# PROPOSED SITE DEVELOPMENT

## 46-64 MAPLEWOOD AVENUE

## PERMIT SITE PLANS

PLAN SET ISSUED: 6 FEBRUARY 2018

**DEMOLITION PLAN** **C2**

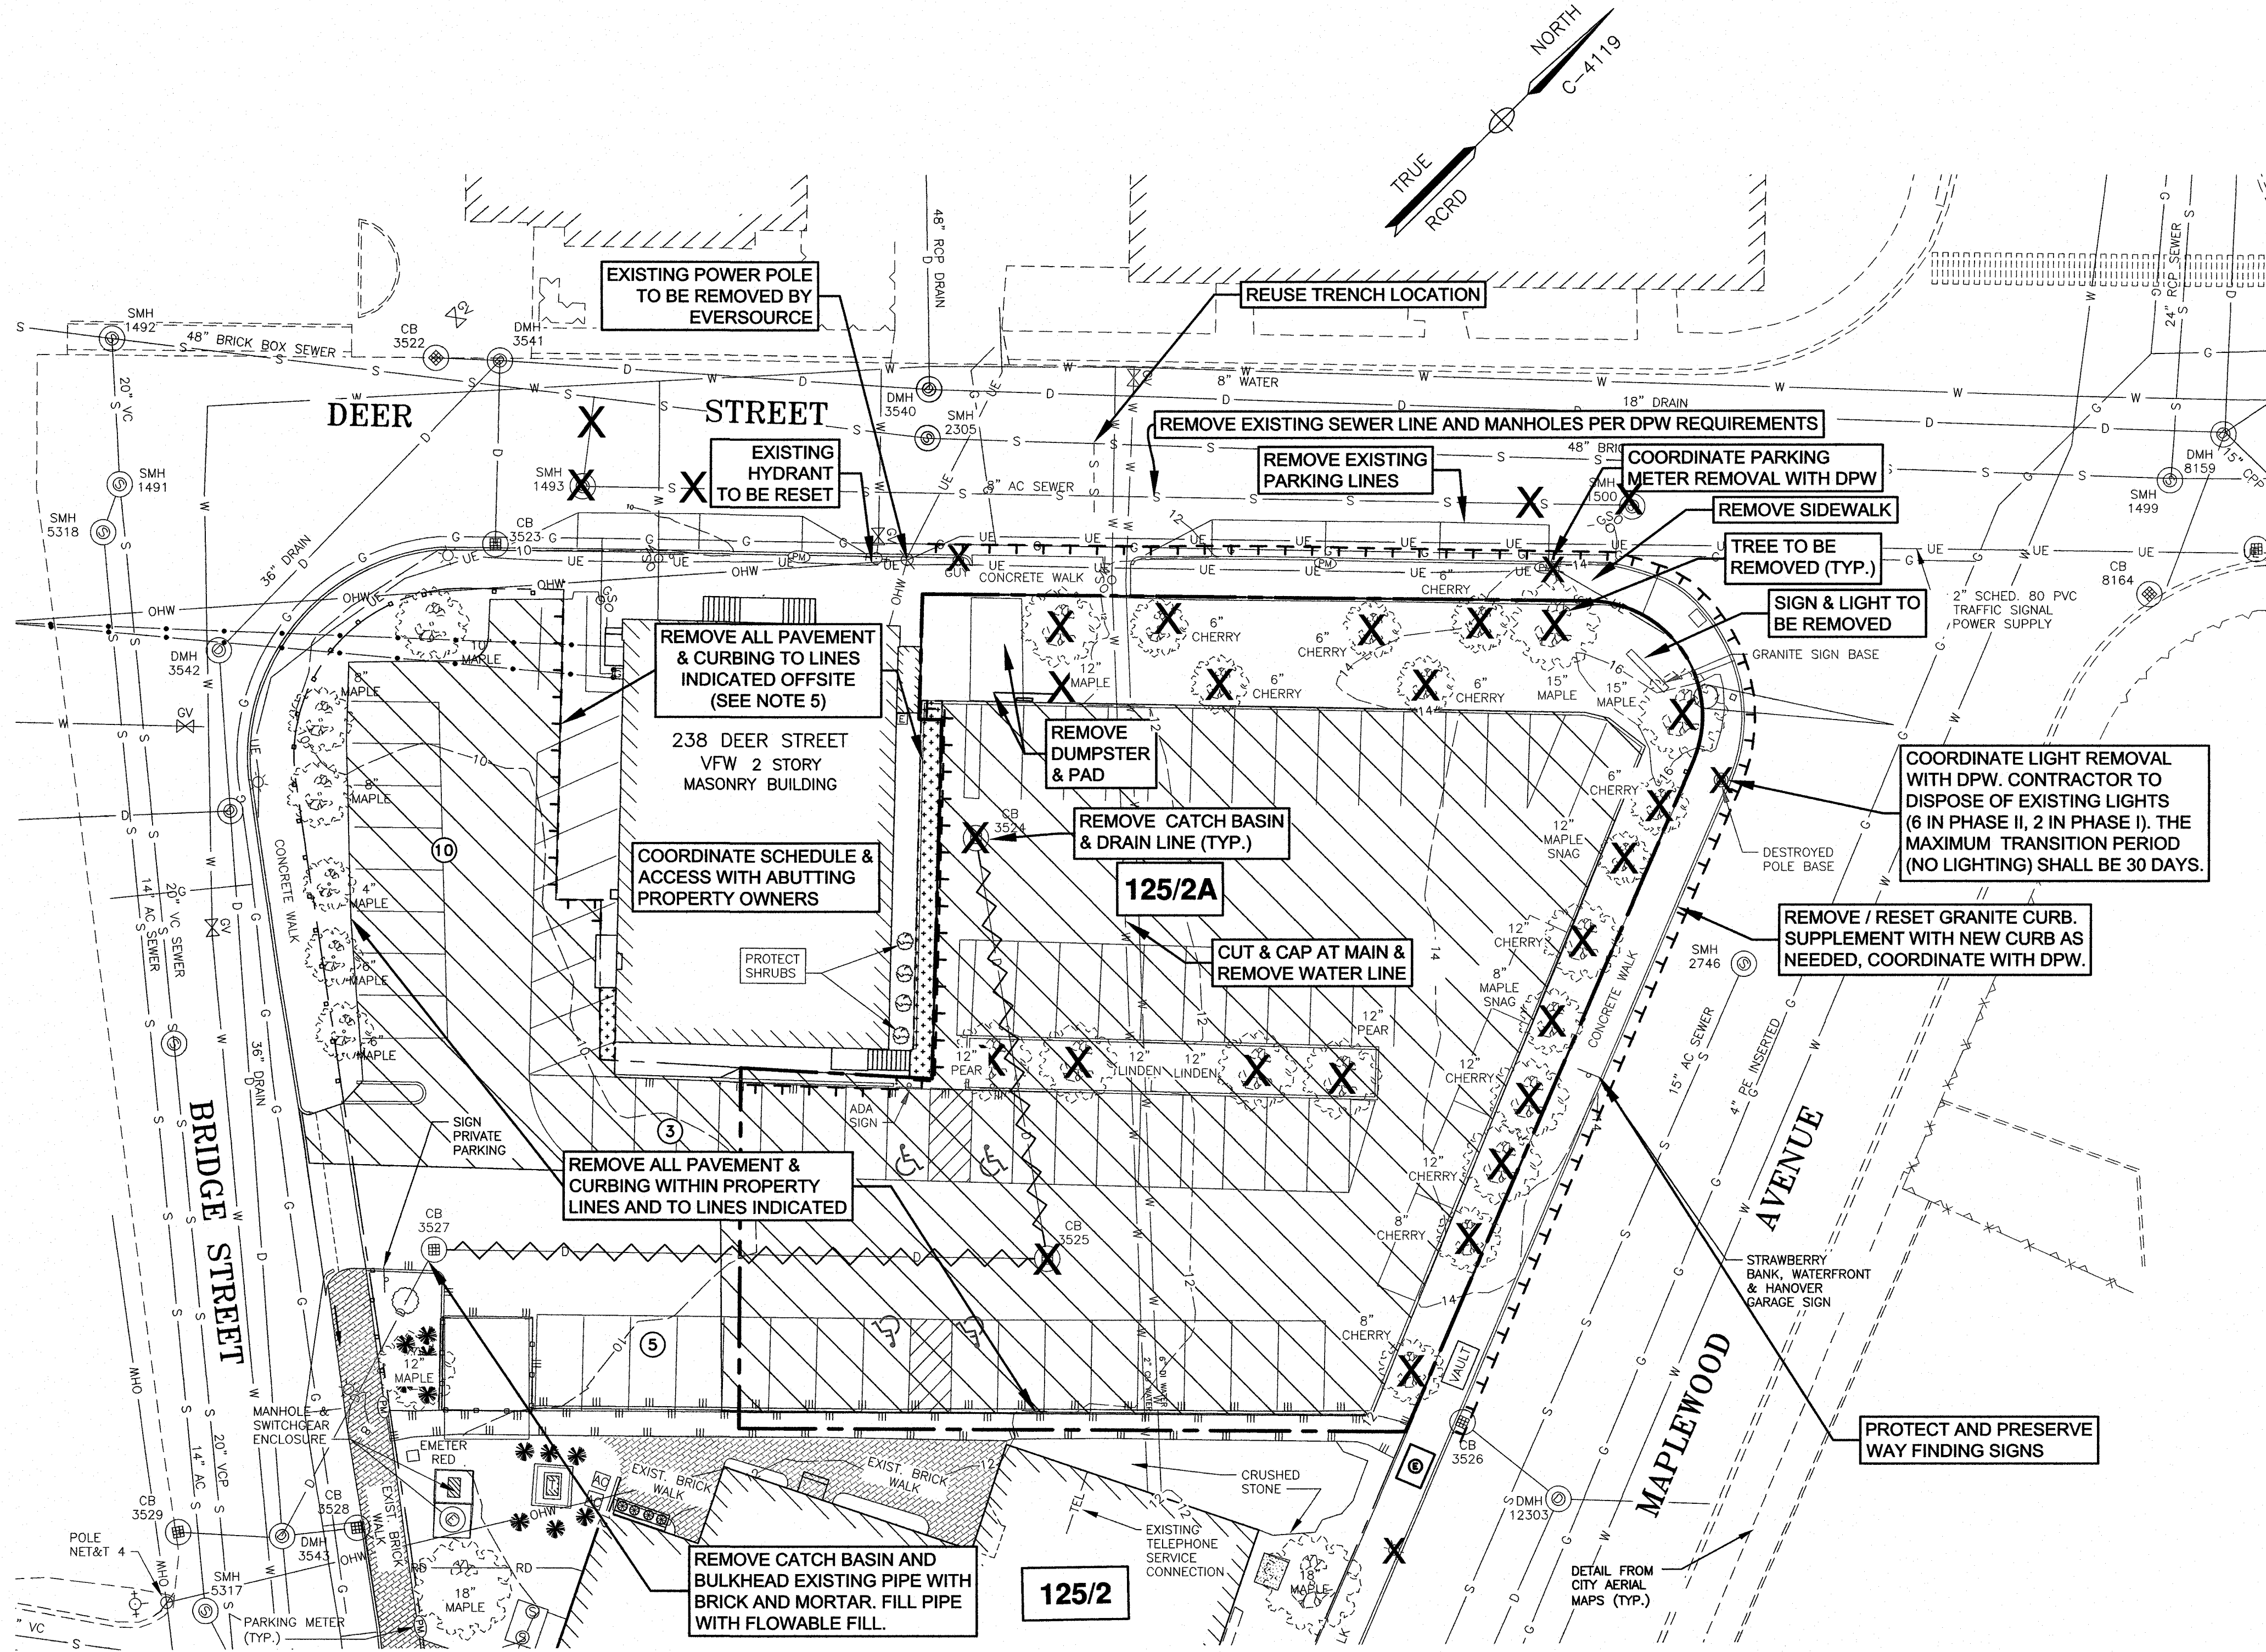
- h. Remove 6" CI gas line from plan as it is out of service. **This has been reflected in Sheet C2.**
  - i. The Tideflex valve shall be relocated to the outlet of DMH1 and an inside pipe friction mounted valve shall be specified. **This has been reflected in Sheet C6.**

**8 GRANITE BANDING**  
Scale: NTS

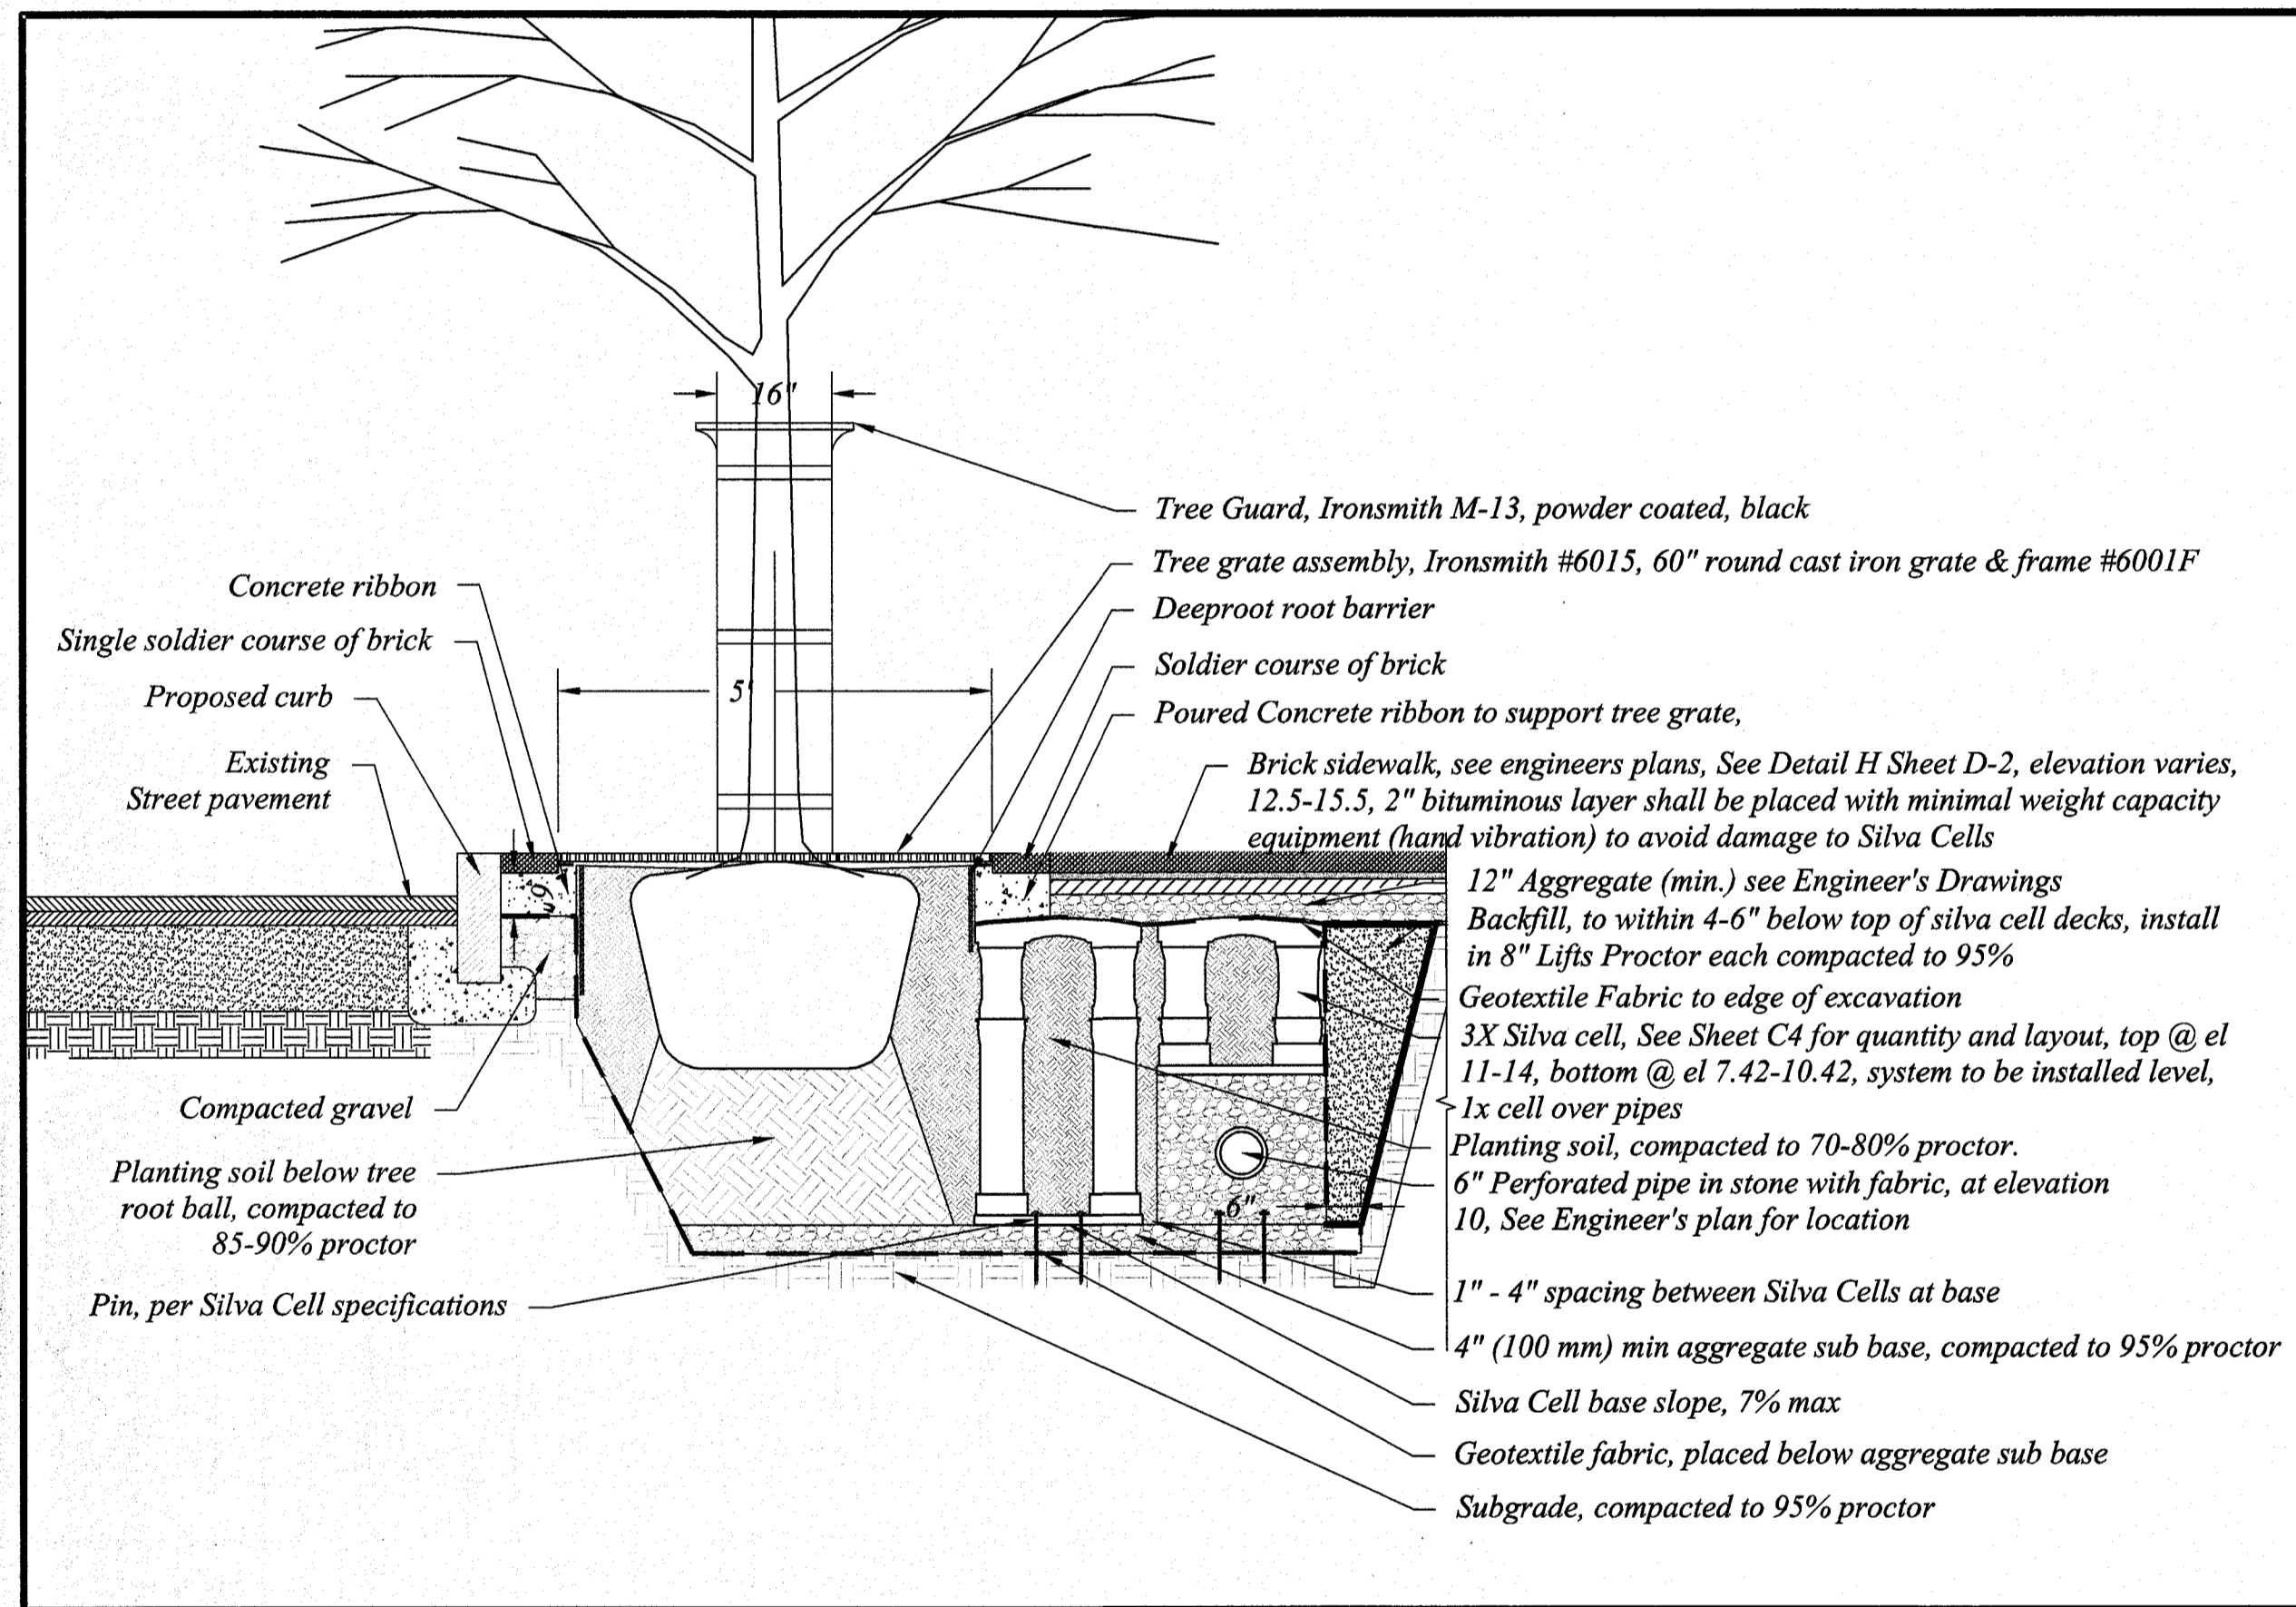
- b. Revise L-3 Landscape Plan to include detail specifications for granite banding in the sidewalk. **This has been added to Sheet L-3 as Detail Number 8.**

**C3**

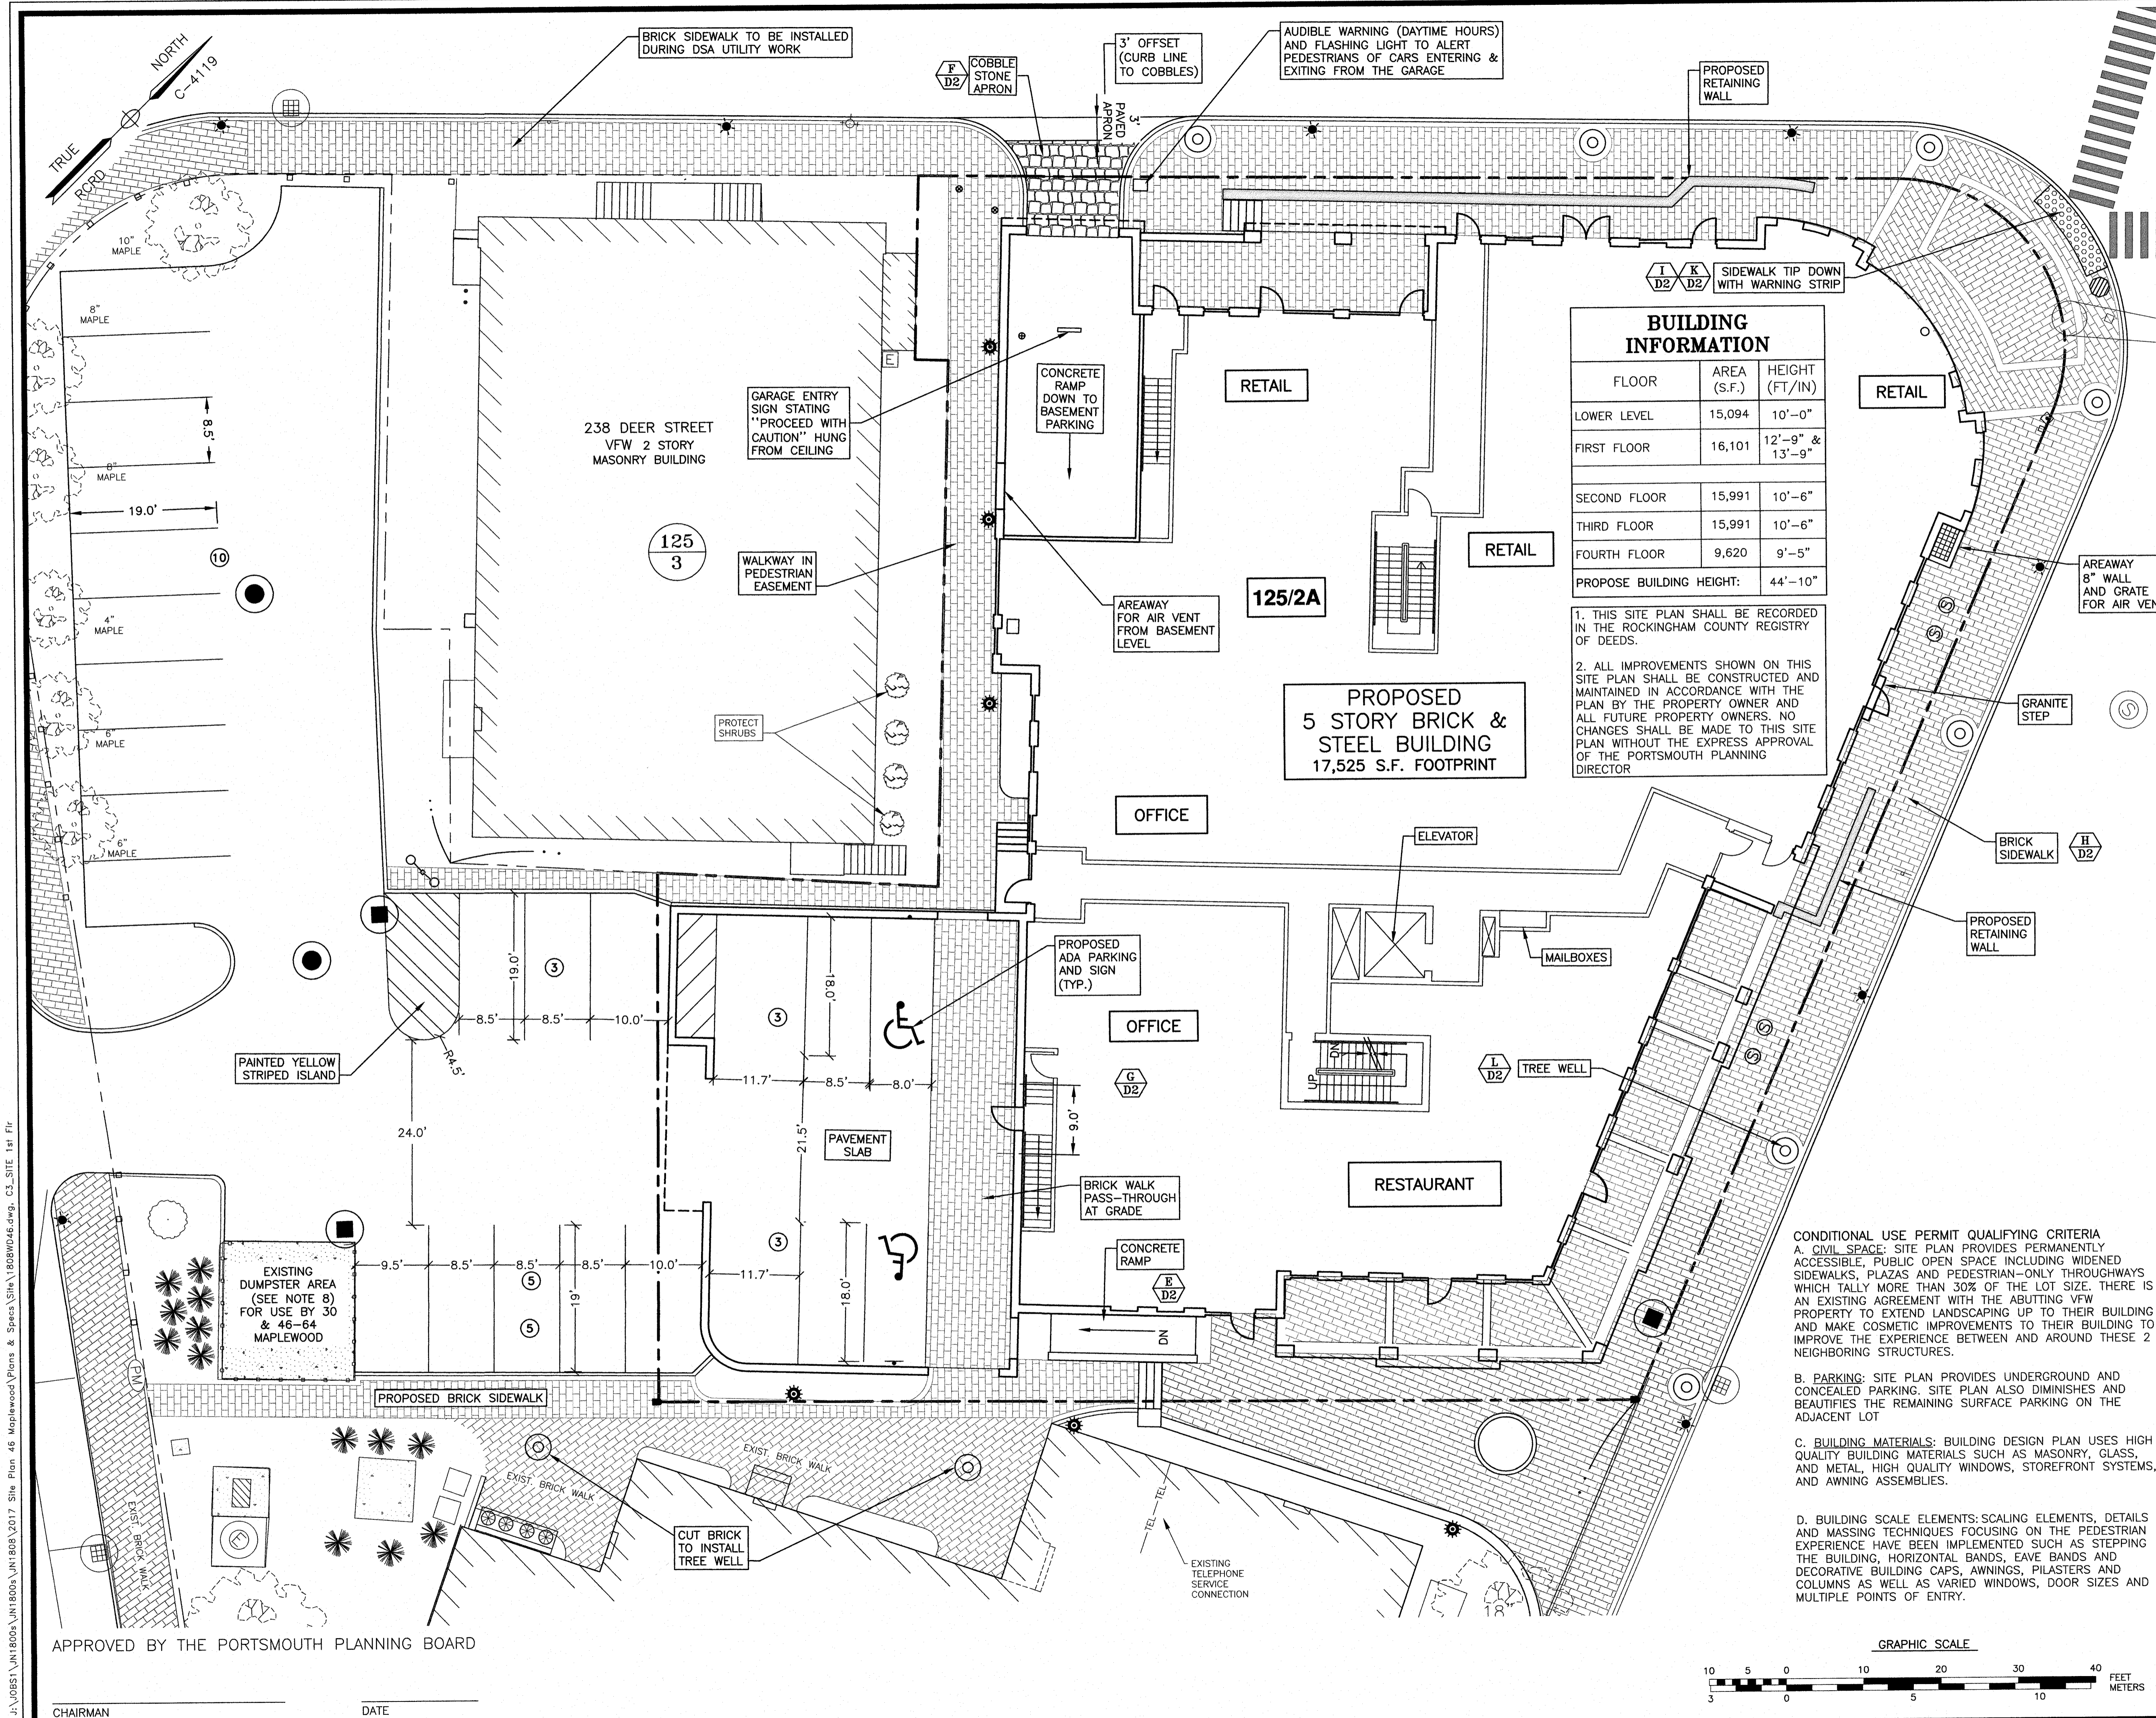
- c. Show brick sidewalk on Deer Street and Bridge Street to be constructed as part of this site plan approval. **This has been reflected in Sheets L-1 and C3.**

- d. Revise note on snow removal and clarifications in the easement agreement on responsibilities. Reference to snow storage being removed off-site will not be stored on City property. **This has been reflected in Sheet C3 as Note 7.**
